# **ADDENDUM NO. 1**

# **NCSU** Renovations to the Don Ellis Building

SCO ID# 19-21547 NCSU ID# 201920037 SFK PROJECT NO. 1368-20

December 5, 2023

**A-100**

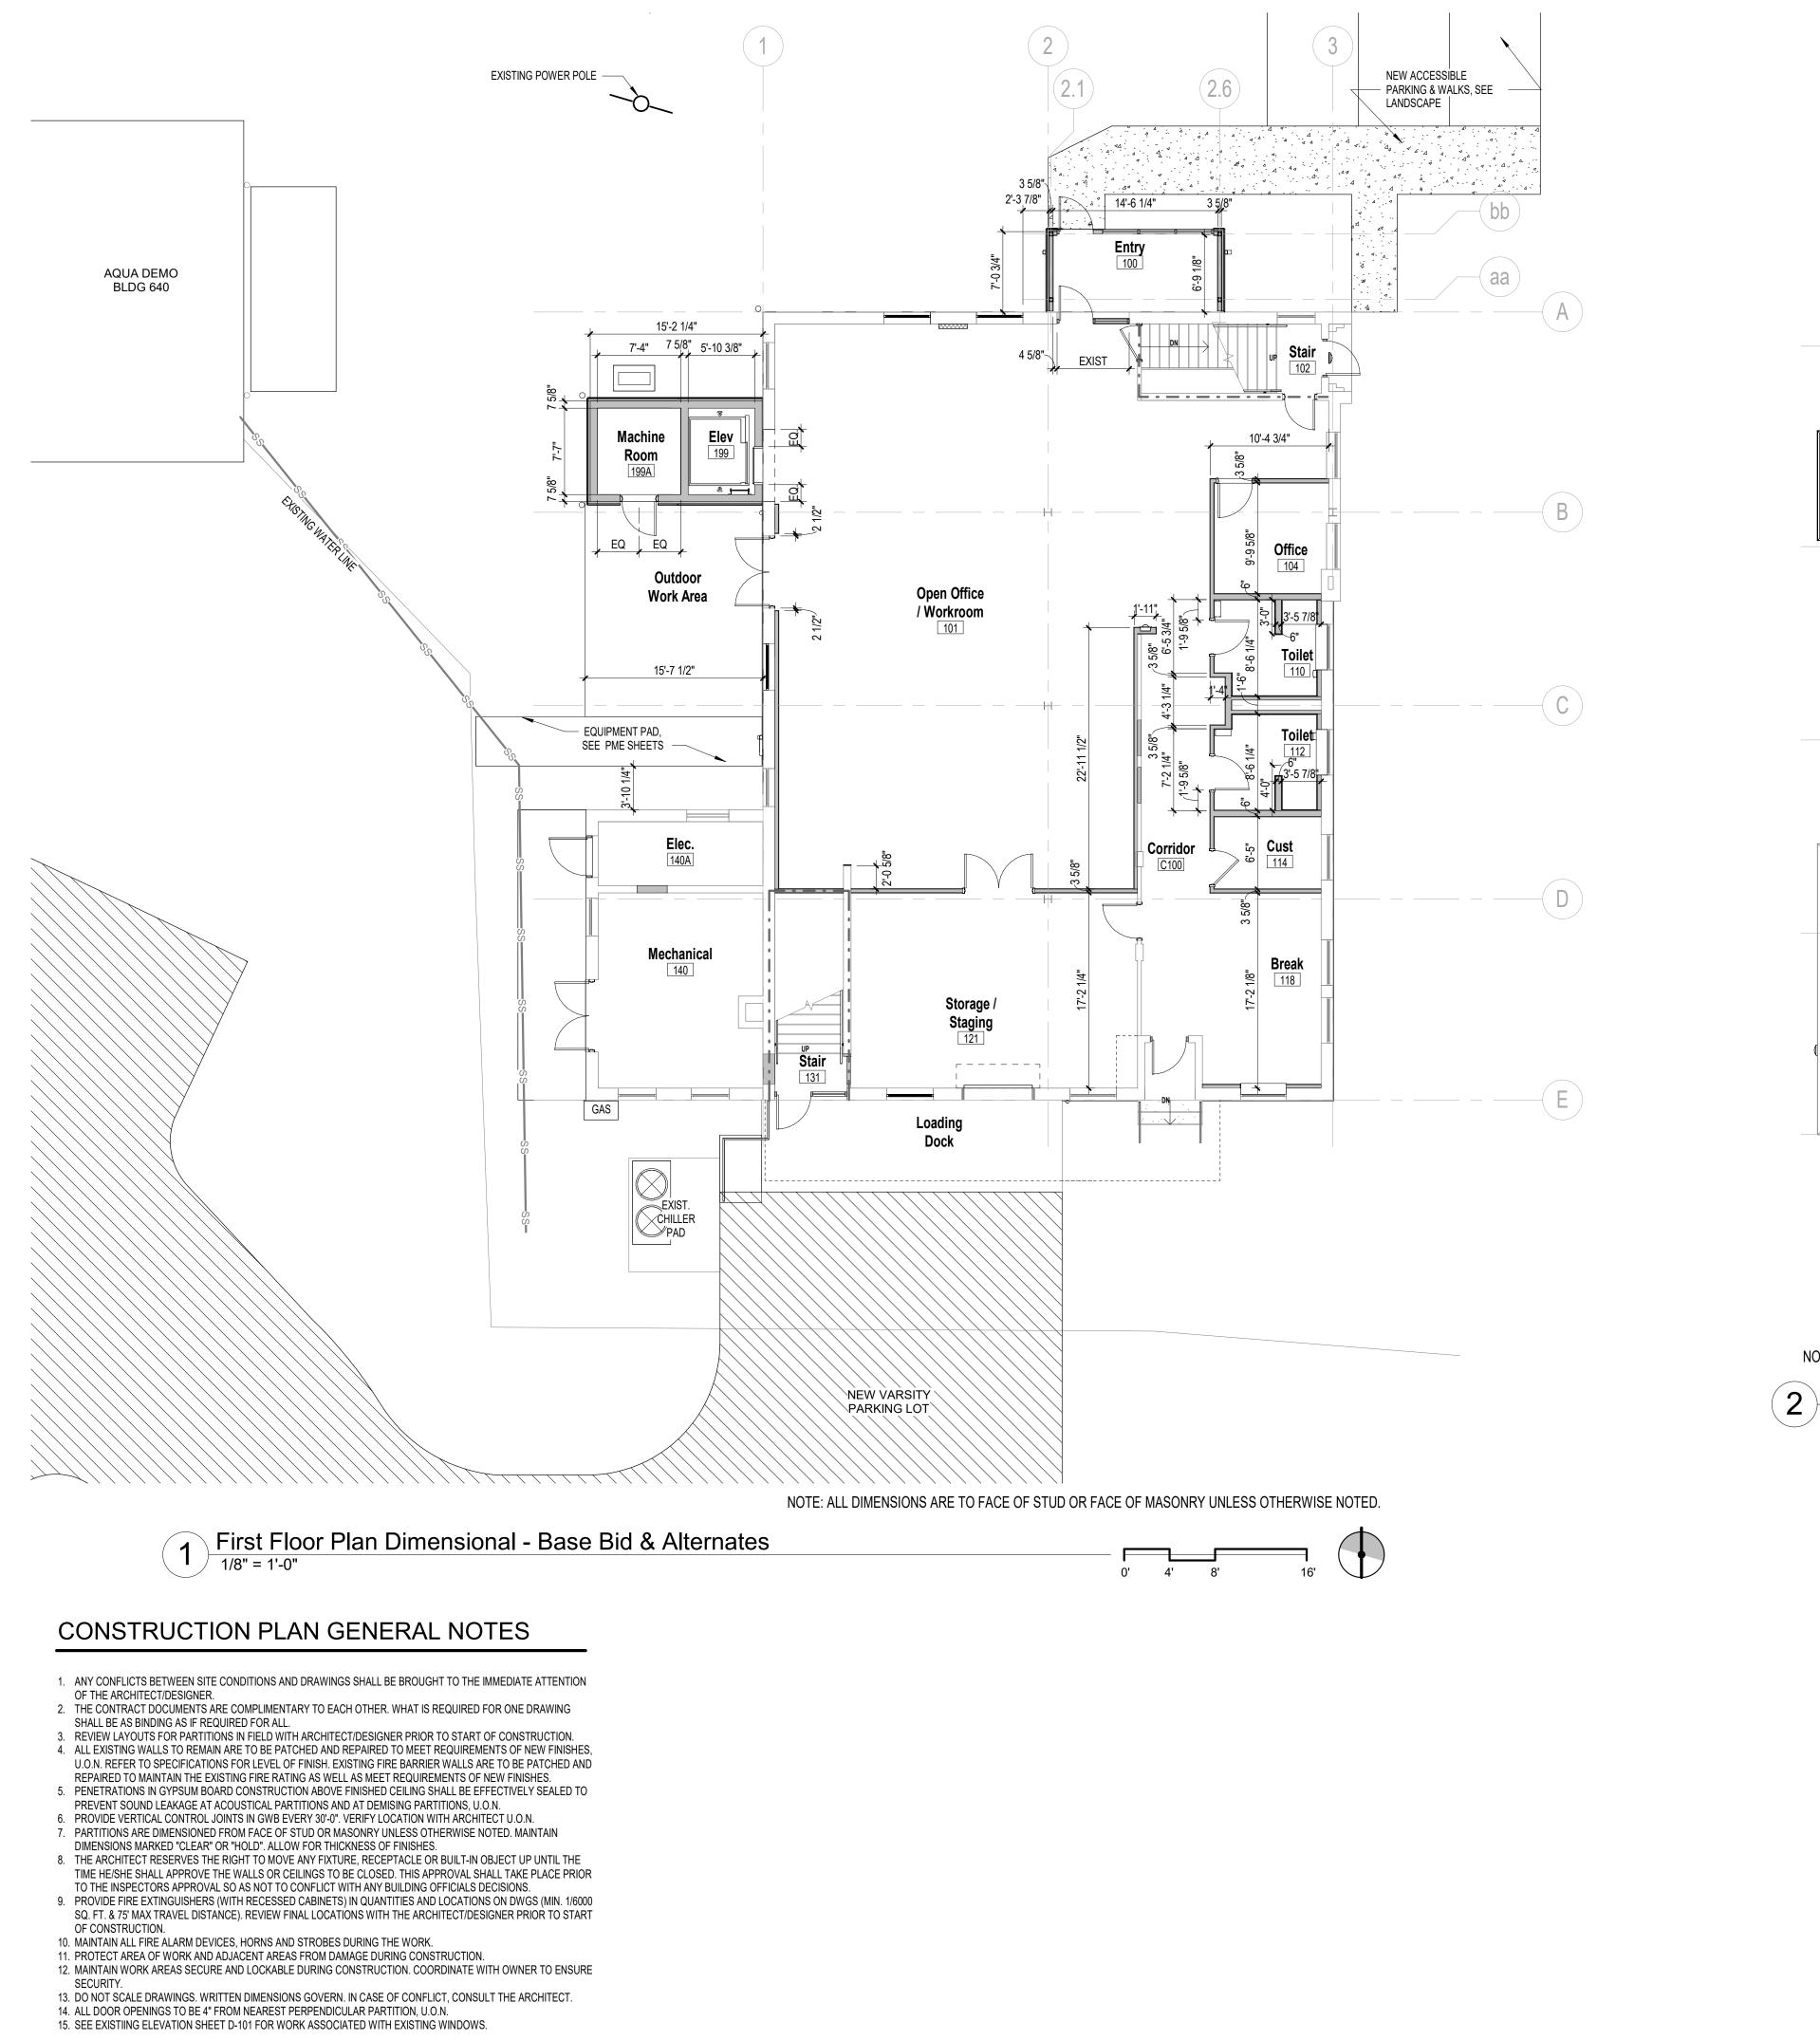
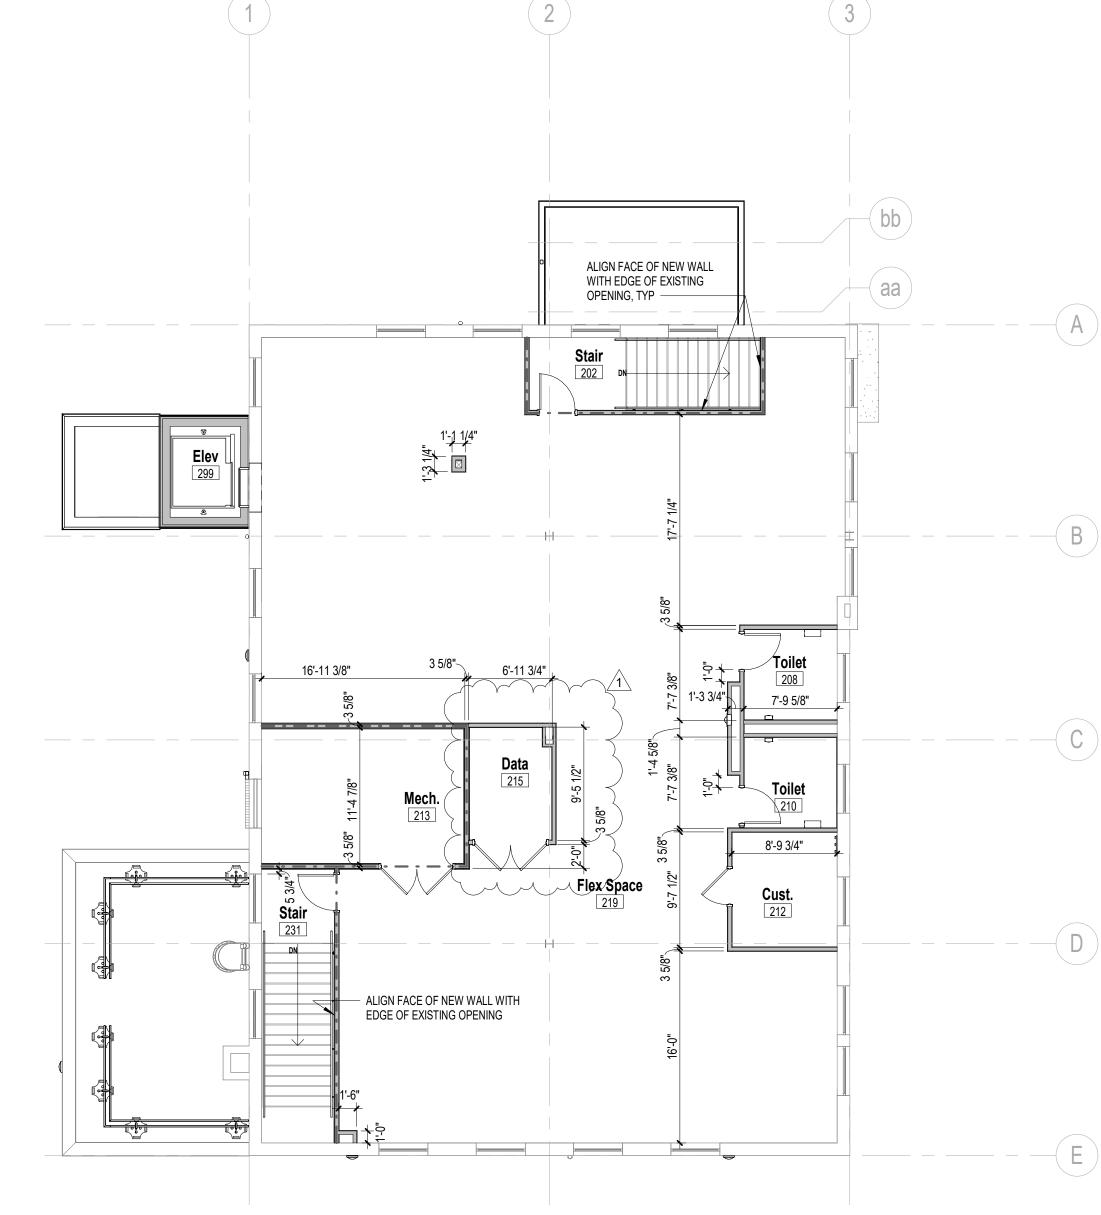
- 1. Sheet D-100: **Replace** with sheet D-100 attached
  - a. Additional notes are added to the sheet
- 2. Sheet A-100: *Replace* with sheet A-100 attached

- a. The door location for the data closet is changed.
- 3. Sheet A-101: *Replace* with sheet A-101 attached
  - a. The door location for the data closet is changed.

**Exterior Elevations**

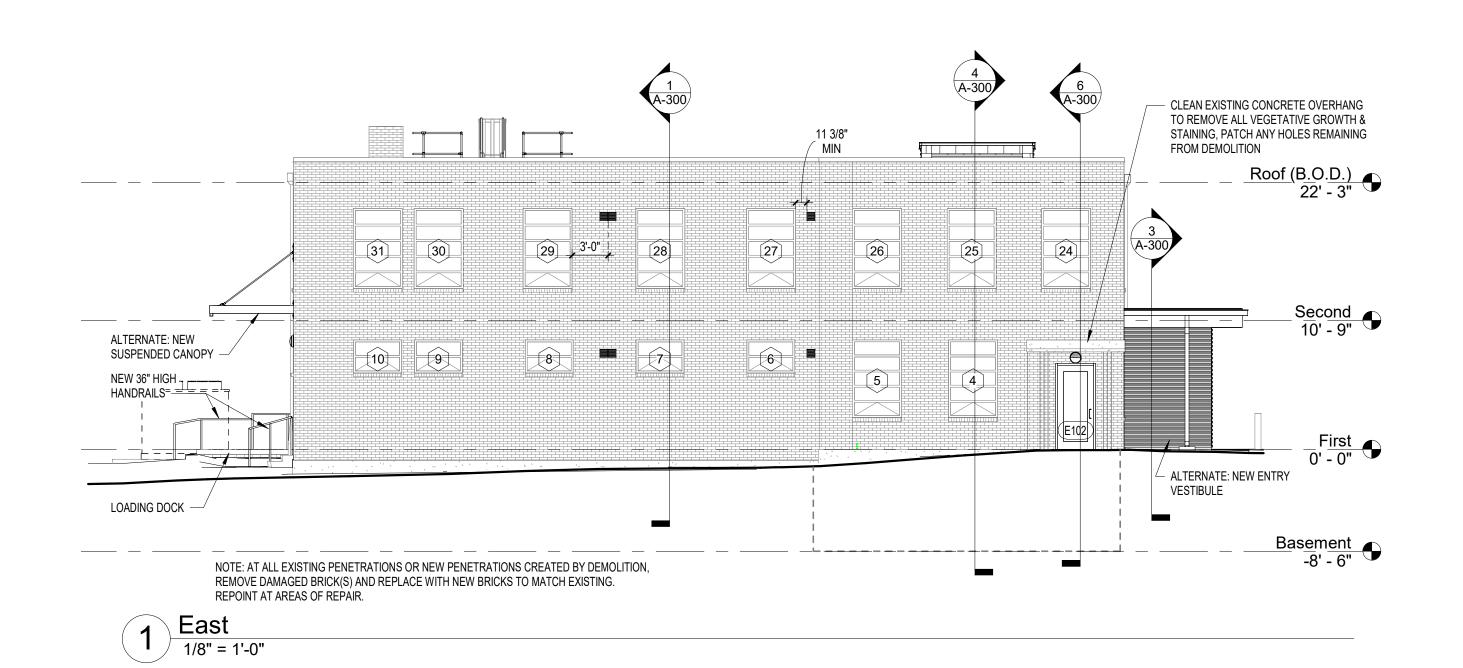
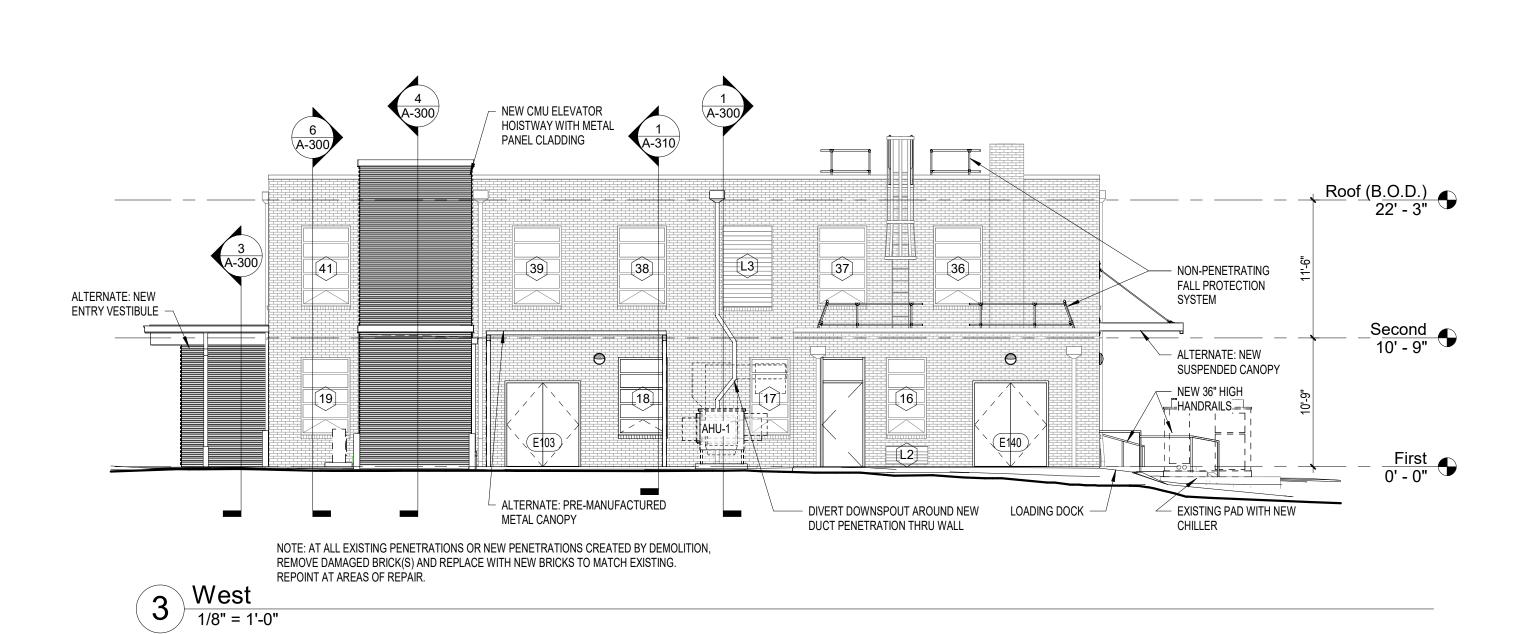
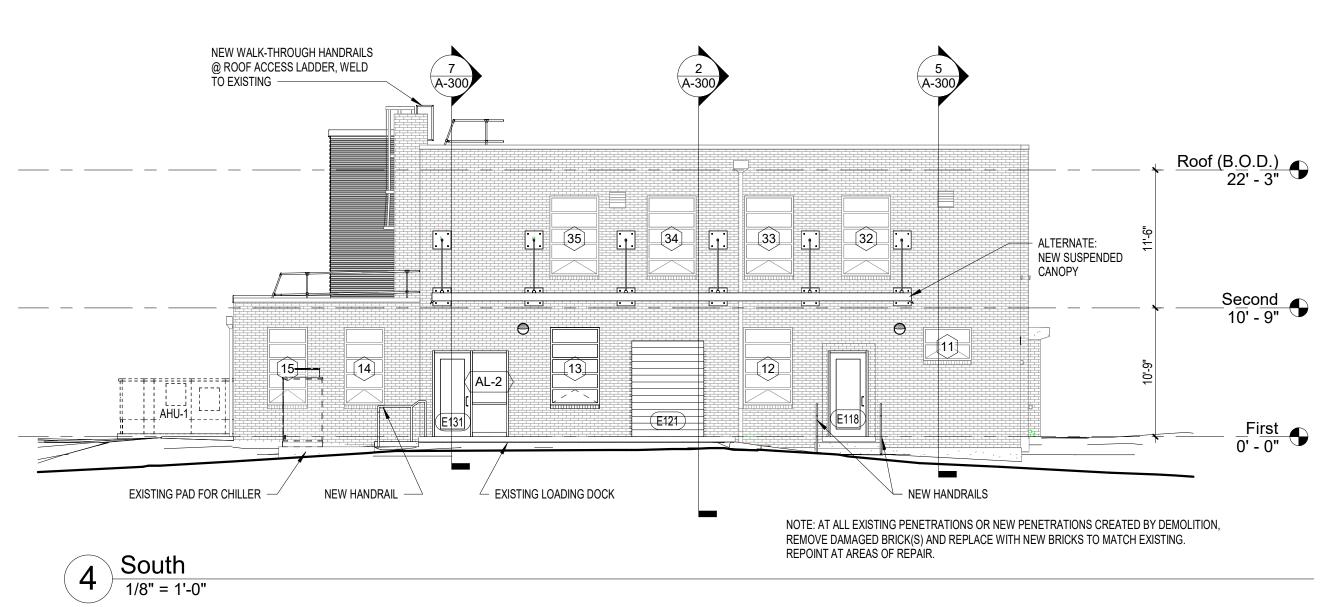
- 6. Sheet A-111: Replace with sheet A-111 attached
  - a. The door location for the data closet is changed.
- 7. Sheet A-200: *Replace* with sheet A-200 attached

- a. Side elevation at mechanical electrical room provided
- 8. Sheet A-700 : *Replace* with sheet A-700 attached
  - a. Accent walls indicated
- 9. Sheet L-100; *Replace* with sheet L-100 attached.

North Elevation @ Electrical Room
